PUNCH ITEM #17

Cracked corner bead at closet return, Room 412

Uneven LVT-to-stone transition at lobby entrance

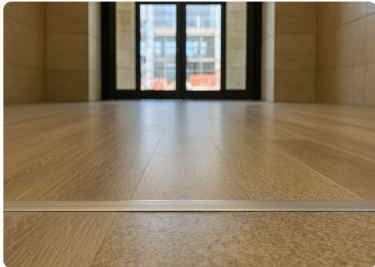
Height mismatch and a visible gap where the lobby LVT plank flooring meets the stone entry threshold — transition strip wasn't seated flush, creating a trip hazard right at the main entrance. Needs the strip reset and, if needed, additional leveling compound under the LVT edge.

Dan — transition strip at the main lobby entrance isn't flush, there's a lip catching toes. This is the first thing every guest and the ownership group will step on, want your flooring crew on it before the punch walk.

Slab must've been slightly low right at the threshold. We'll pull the strip, add leveling compound under the LVT edge, and reset it flush.
-

Leveled the subfloor edge, reset the LVT, and re-installed the transition strip flush and secured. Walked it myself with a straightedge, no lip anywhere across the width. After photo attached.
